DEVELOPMENT REVIEW BOARD MEETING
APRIL 10, 2023
6:30 PM

3. **Resolution No. 415. Primary School in Frog Pond.** The applicant is requesting approval of a Stage 1 Preliminary Plan, Stage 2 Final Plan, Site Design Review, Class 3 Sign Permit and Waivers, and Type C Tree Removal Plan for construction of a new primary school on property located at 7151 SW Boeckman Road.

**DEVELOPMENT REVIEW BOARD
RESOLUTION NO. 415**

Exhibit A1
Staff Report
Wilsonville Planning Division
Primary School in Frog Pond
Development Review Board Panel 'A'
Quasi-Judicial Public Hearing

Block, Access, and Connectivity Consistent with Frog Pond West Neighborhood Plan
Subsection 4.127 (.10) and Figure 18. Frog Pond West Master Plan

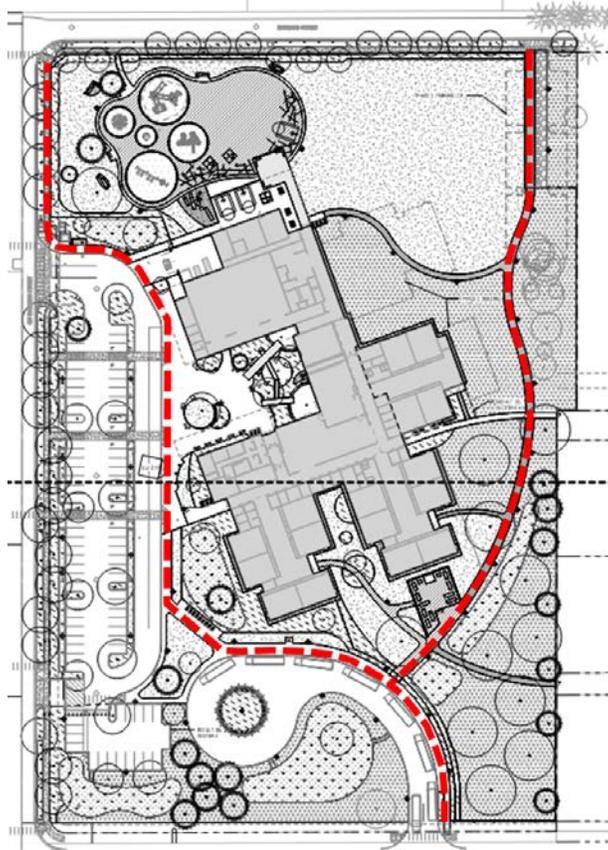
B21. The Street Demonstration Plan is an illustrative layout of the desired level of connectivity in the Frog Pond West neighborhood and is intended to be guiding, not binding, allowing for flexibility provided that overall connectivity goals are met. As shown in the portion of Figure 18 below, SW Sherman Drive borders the subject property on the west, SW Brisband on the north, and SW Boeckman Road on the south, with a Pedestrian Connection connecting SW Brisband Street to SW Boeckman Road on the east side of the school site and west side of the future park site (land banked).

The block size and shape, access, and connectivity of the proposed school site complies with Figure 18 of the Frog Pond West Master Plan or is an allowed variation as shown in the table below.

The applicant has proposed an alternative to the Pedestrian Connection shown in Figure 18 along the property’s east boundary. As described in their Code response and shown in the illustration below, a pathway from the SW Boeckman Road sidewalk travels north along the bus lane to a path that meanders north along the eastern side of the school building to SW Brisband Street. For security purposes, this path will be gated during school hours but opened to the public at other times to facilitate access. During school hours the pedestrian route would continue along the bus lane to the front of the building and then onto the northwest corner of the site along SW Sherman Drive, which then connects to SW Brisband Street, thus completing the intent of the Master Plan while addressing school security.

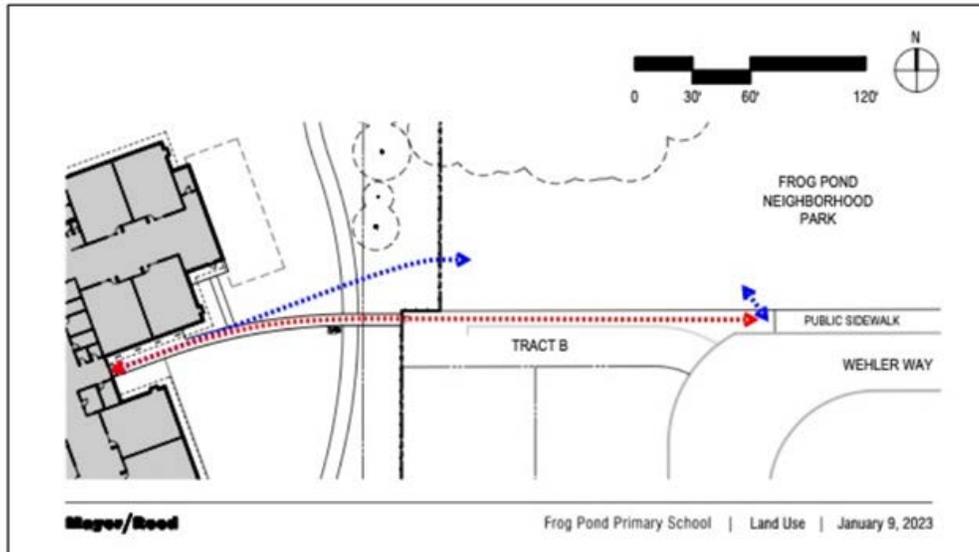
The pathway on the east side of the site that connects the sidewalk along the bus aisle with the sidewalk in SW Brisband Street at the north end of the site is proposed to be a combination of pedestrian asphalt paving, concrete, and/or compacted aggregate paving surface to provide ADA accessibility (see Sheets LU 202 and LU 203 in Exhibit B2). Two (2) pathways connecting the school property to SW Wehler Way also are proposed to be this combination of materials depending on location within the site. As illustrated below, there are two (2) options for the northern connection to SW Wehler Way: through the future City park property (the applicant's preferred option); or on the north side of private Tract B in the Stafford Meadows subdivision.

Frog Pond West Specific Fence Standards
 Subsections 4.127 (.17)

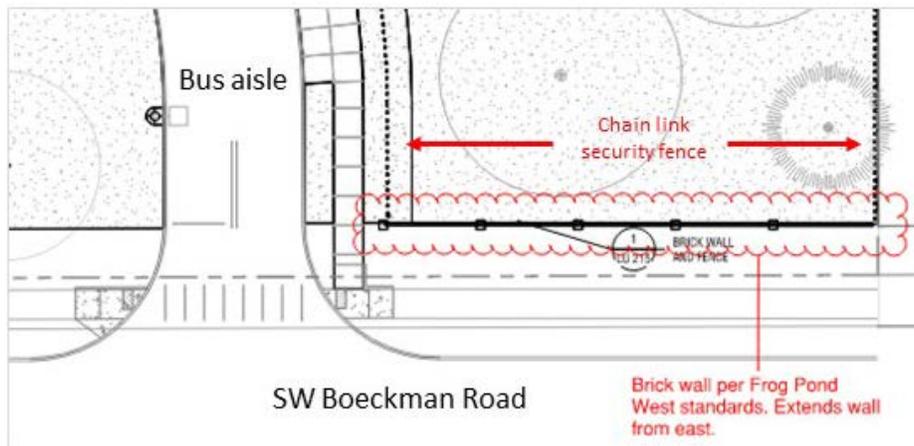
B22. Within Frog Pond West, fences must comply with standards in 4.113 (.07) except that columns for the brick wall along SW Boeckman Road are to be placed at lot corners where possible; a solid fence taller than four (4) feet in height is not permitted within eight (8) feet of the brick wall along SW Boeckman Road except for fences placed on the side lot line that are perpendicular to the brick wall and end at a column of the brick wall; and height transitions for fences must occur at fence posts. As shown in the illustration below, the applicant proposes a brick wall along the SW Boeckman Road frontage at the southwest corner of the site as an extension of the existing brick wall to the east. The wall is proposed to stop at the east edge of the bus entry driveway; no brick wall is proposed on the west side of the bus aisle to the southwest corner of the site. As described by the applicant, this proposed gap in the wall will improve visibility to and from the school site, benefiting security as well as navigation to the school. The gap will also serve to emphasize the native plantings and stormwater features at the southwest corner and along the southern edge of the property. A detail of the brick wall that is consistent with the standards of Section 4.127 (.17) and the Frog Pond West Master Plan is included in Sheet LU 215 of the applicant's materials (Exhibit B2).

A perimeter 6-foot high chain link security fence is proposed to enclose areas occupied during the school day, such as the playground, field, and classroom wings in the north and east portions of the site to protect building entries and students and staff during school time exterior activities. The parking area and main building entry on the west side of the site, and the bus drop-off/pick-up area are outside the fenced area and open to the public throughout the day. The fence gates will be locked during school hours but opened at other times to facilitate community access to interior pathways, playground, and fields. As shown in the illustration above, the security fence is perpendicular to the brick wall along SW Boeckman Road as required. The applicant’s Sheet LU 217 (Exhibit B2) provides a detail of the chain link fence design.

Mixed Solid Waste and Recycling Areas Location Standards Subsection 4.430 (.02)

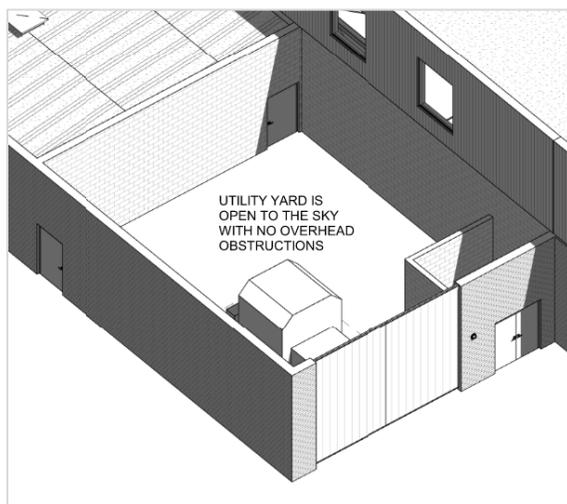
- C7. The proposal provides a storage area for solid waste and recyclables at the northwest corner of the building. As noted in Findings B78 and B79, the proposed storage area is approximately 717 square feet in size within a 1,380-square-foot utility yard, which substantially exceeds the requirement of 289 square feet for the proposed primary school use.

Collection Vehicle Access, Not Obstruct Traffic or Pedestrians
Subsections 4.430 (.02) G.

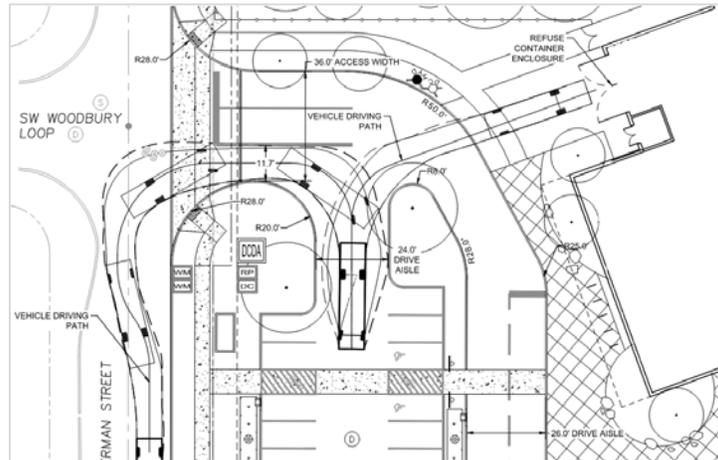
C10. The letter from Republic Services, included in the applicant’s materials in Exhibit B1, indicates the location and arrangement is accessible to collection vehicles, as shown in the illustration below. The location of the storage area does not impede sidewalks, parking area aisles, or public street right-of-way.

Subsection 4.156.02 (.08) A. 1.

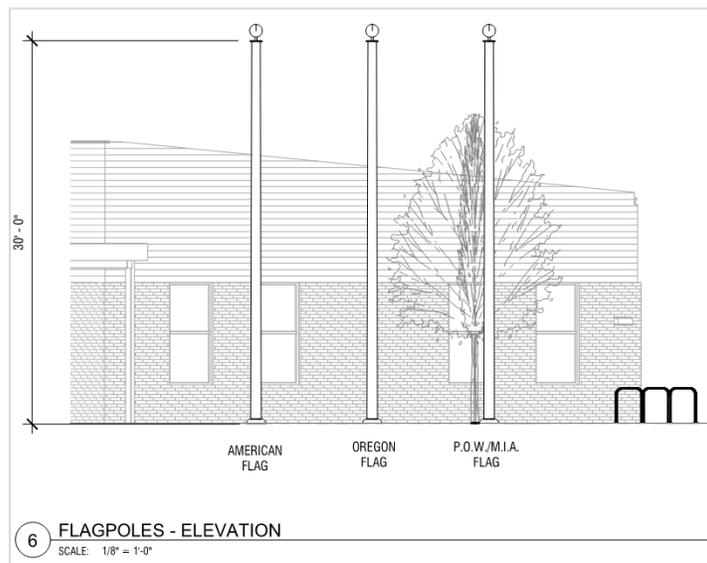
D12. With respect to the third flagpole, as stated by the applicant, three (3) flagpoles are required by the State of Oregon (Policy 107-011-160 established effective January 1, 2018) to fly the required United States flag, State of Oregon flag, and National League of Families' POW/MIA flag. The proposed configuration, illustrated below, will allow the three (3) to be displayed properly when half-mast protocol is in effect. Each pole will be adequately lit from above. The third flagpole is complementary in design and placement to the two (2) allowed by the standard while meeting the State requirement.

3 MONUMENT SIGN ELEVATION - FRONT & BACK
 SCALE: 1" = 1'-0"

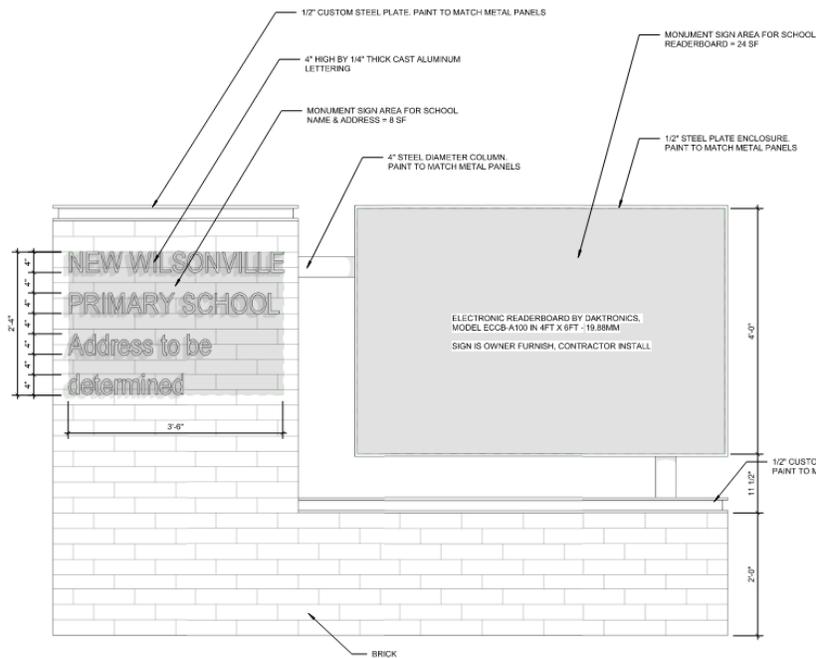
Including an electronic reader board in the proposed monument sign, as described in the applicant's narrative, improves sign functionality by facilitation remote regulation of the sign's operation by the school, allowing easy message changes and real-time updates to the signage outside the school, and enabling the District to inform school visitors of upcoming events, or announce school closures or delays in the event of inclement weather. The proposed design is for text only, in one color of red, with no display of graphics or animations, oriented to be seen along SW Sherman Drive at the main entry to the school.

Subsection 4.156.08 (.02) B.5.a

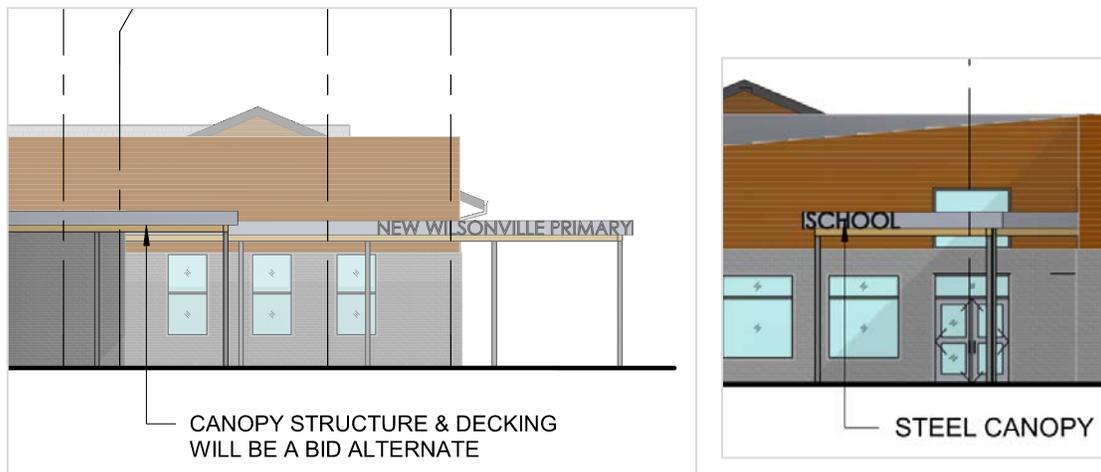
D29. As described by the applicant and shown on the plans and in the illustration below, the building-mounted sign is proposed to be located on the walkway canopy near the main front entrance, and will wrap around the west corner of the canopy. The northwest facing portion of the sign is 41 square feet (Sheet LU 350) on a building façade in excess of 140 feet, and the west facing portion of the sign is 13 square feet on a façade length over 370 feet. The code allows a sign area of 36 square feet for building facades lengths greater than 72 feet with an allowance to 12 additional square feet of sign area for every additional 24 feet of façade length. Each portion of the sign easily satisfies this standard. No signs are proposed on the north or south façades.

SHEET NUMBER
LU 203

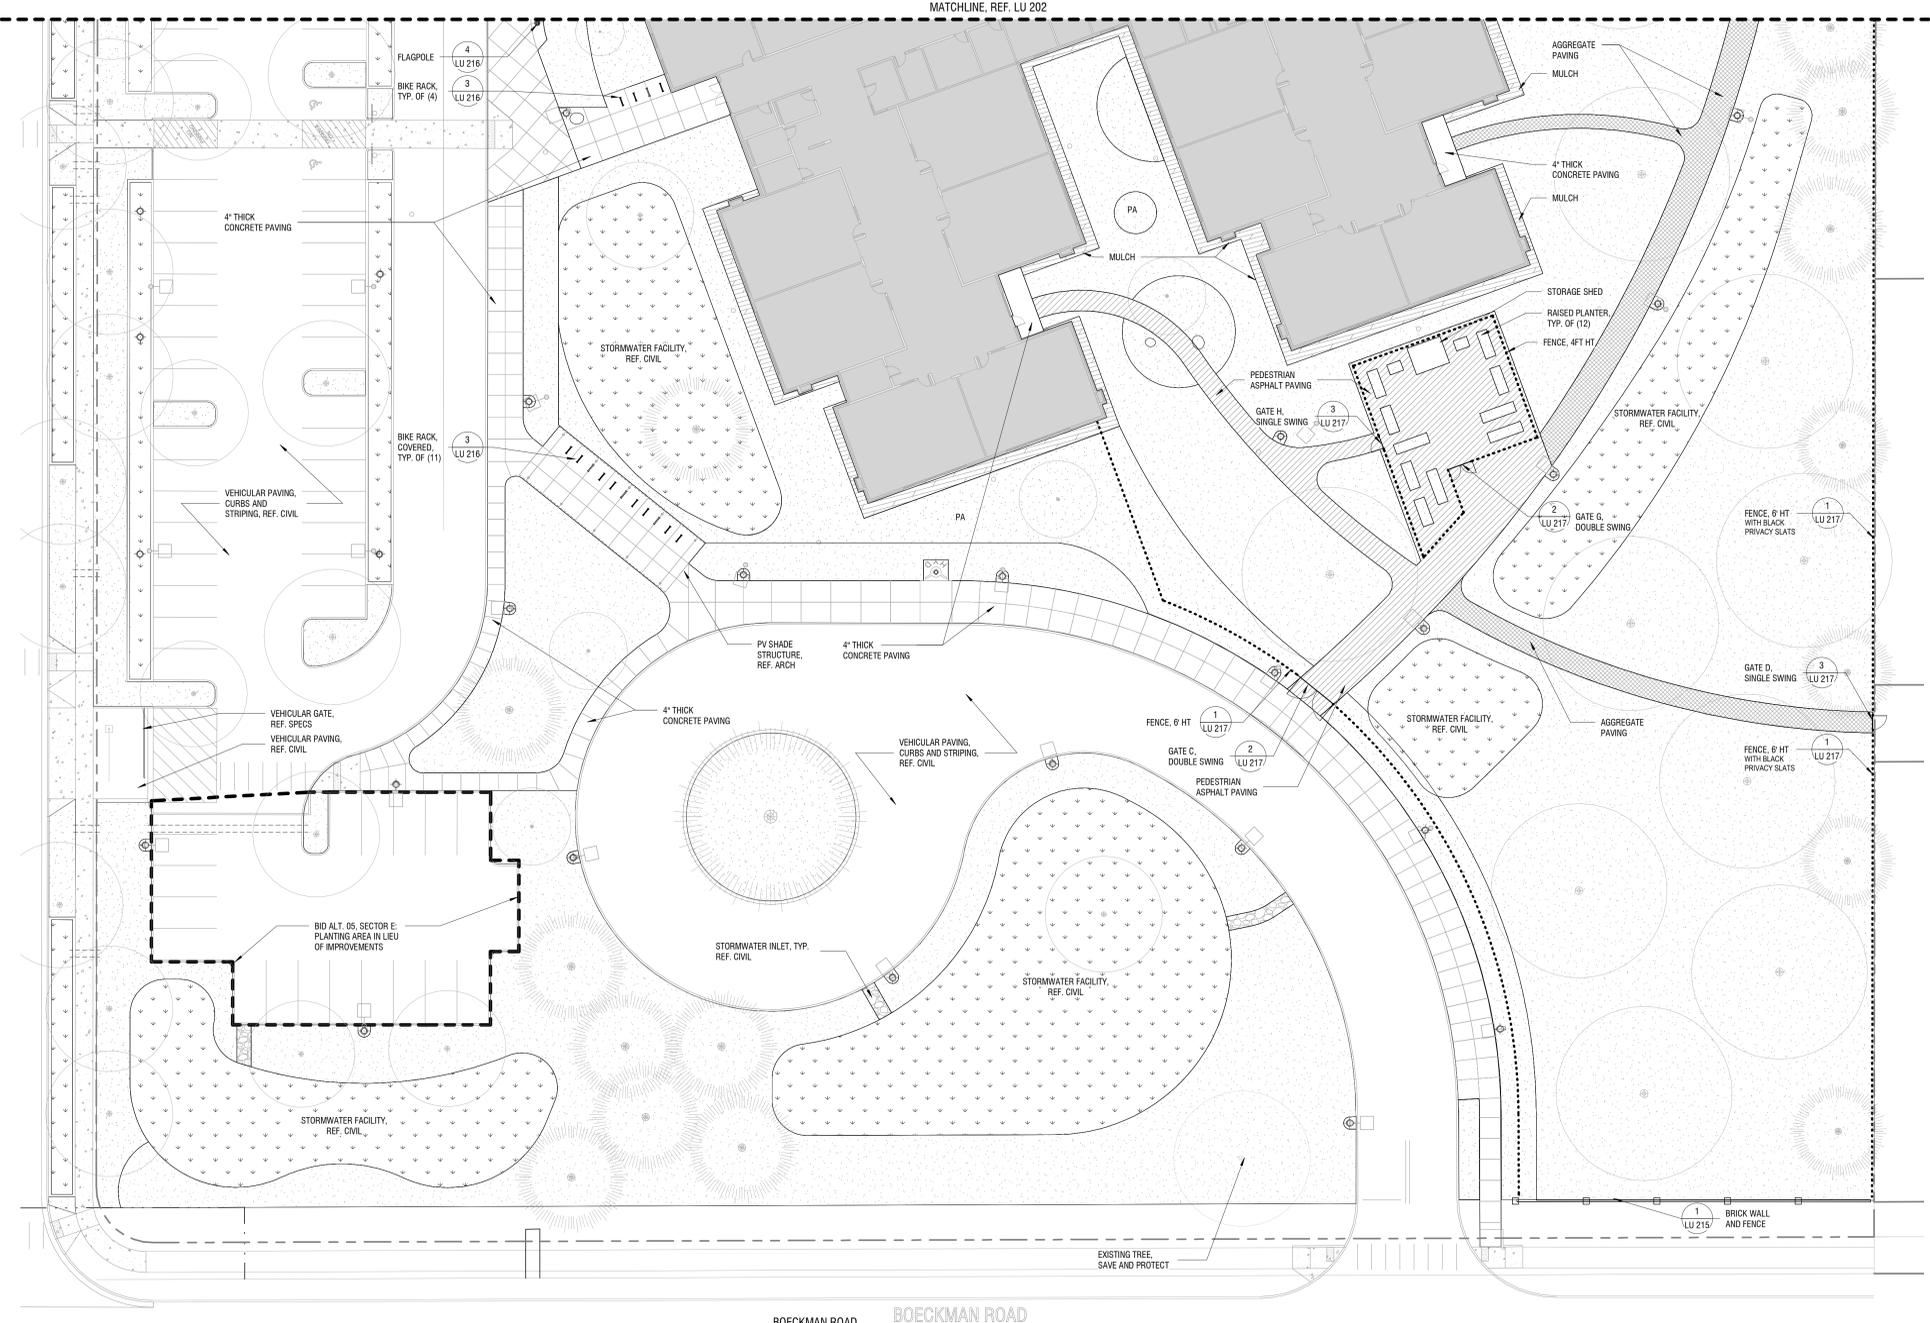
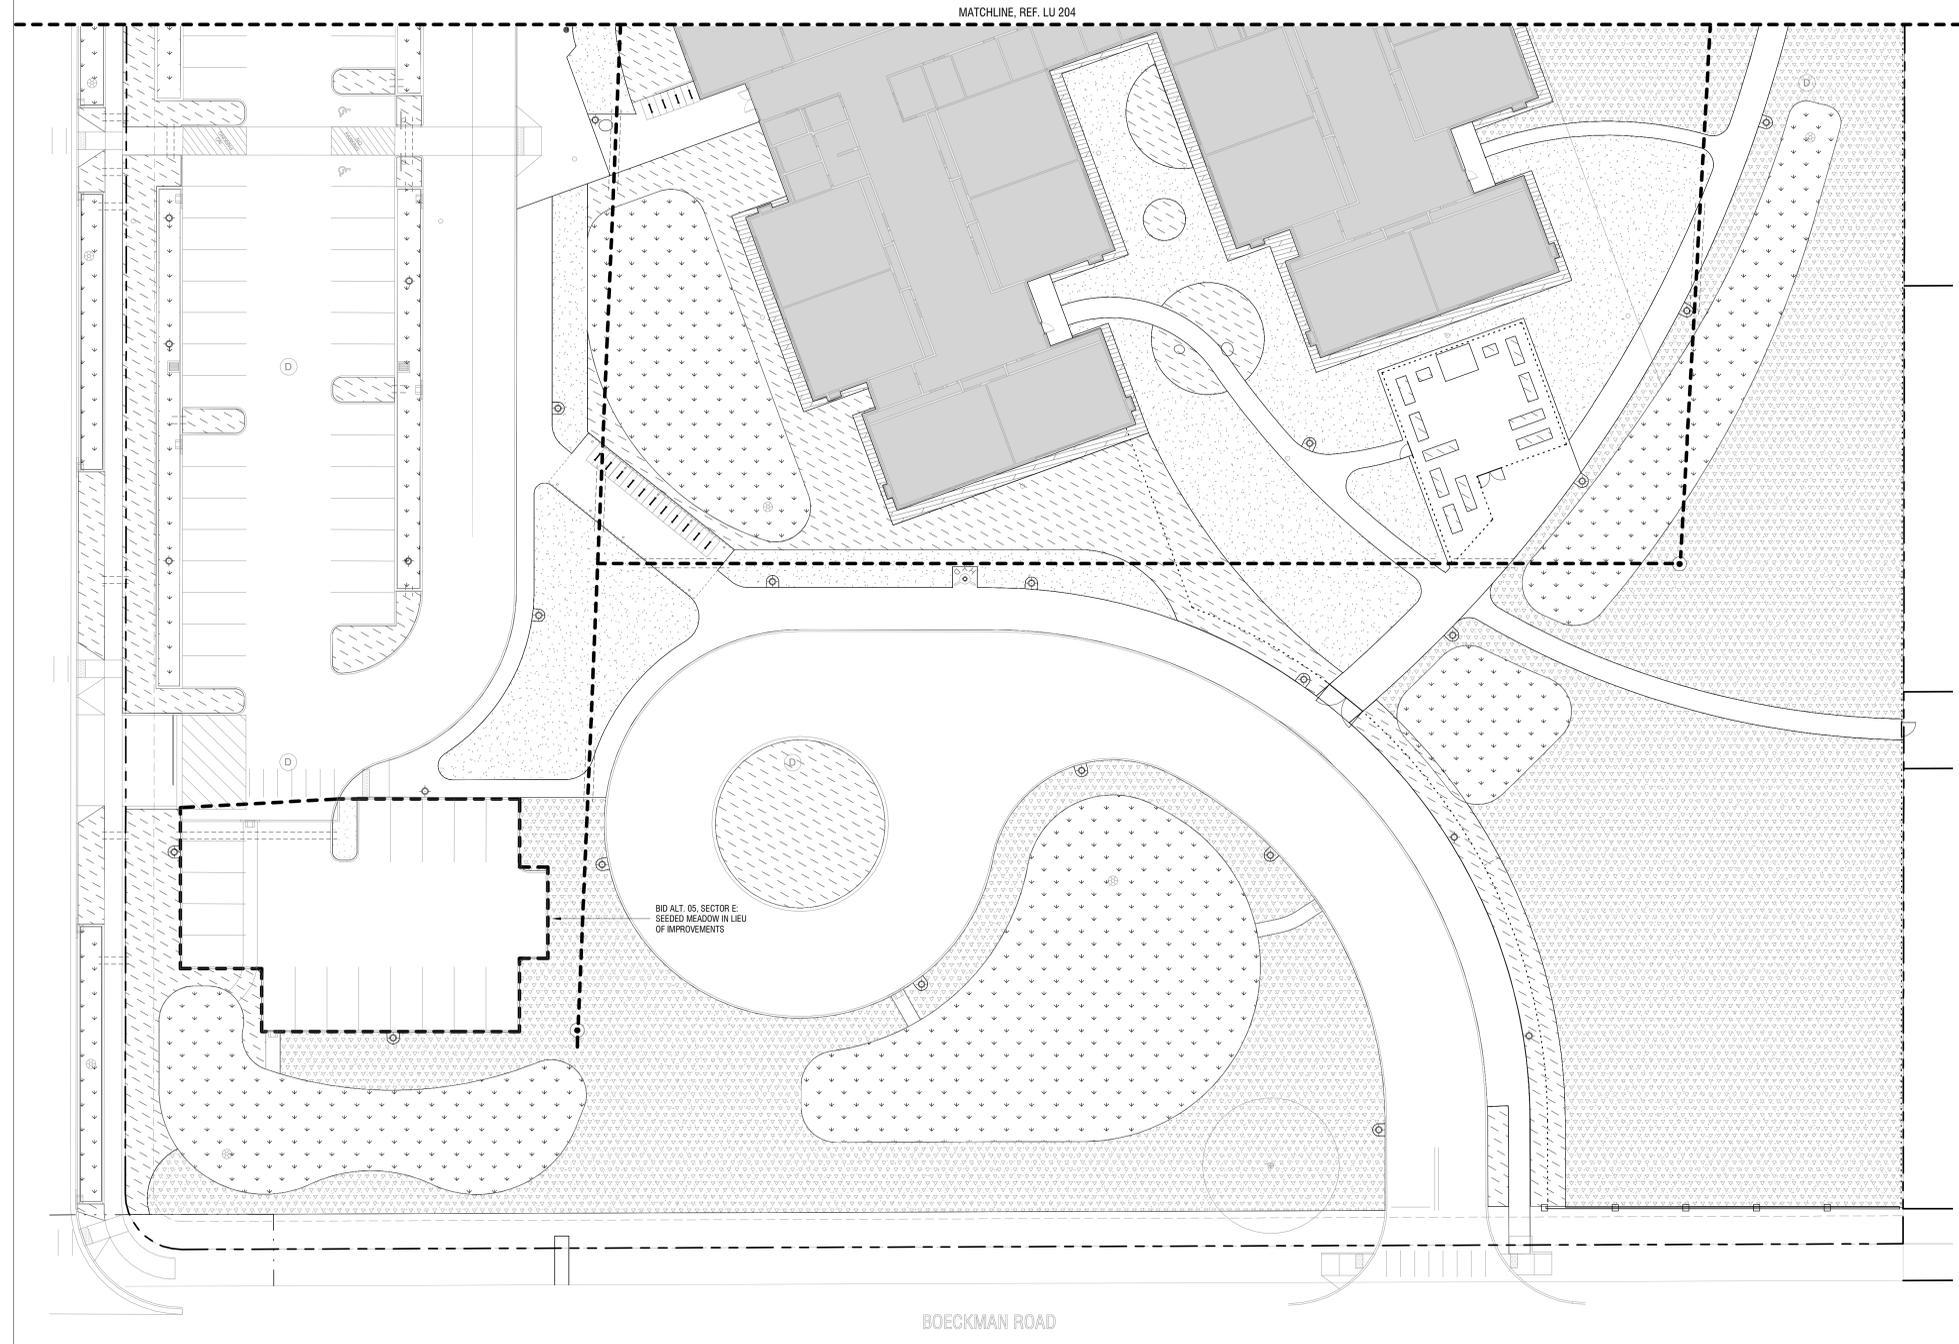
Response: Several plan sheets inadvertently were missing 6 spaces for Phase 1, and this has been corrected. Two additional racks (4 spaces) are proposed under the freestanding canopy in front of the building, and one rack is added at the west administration entry. This information and clarification regarding covered bicycle spaces are shown on revised application plan sheets LU 200, LU 203, LU 205, LU 208, LU 209, and LU 213, which are attached.
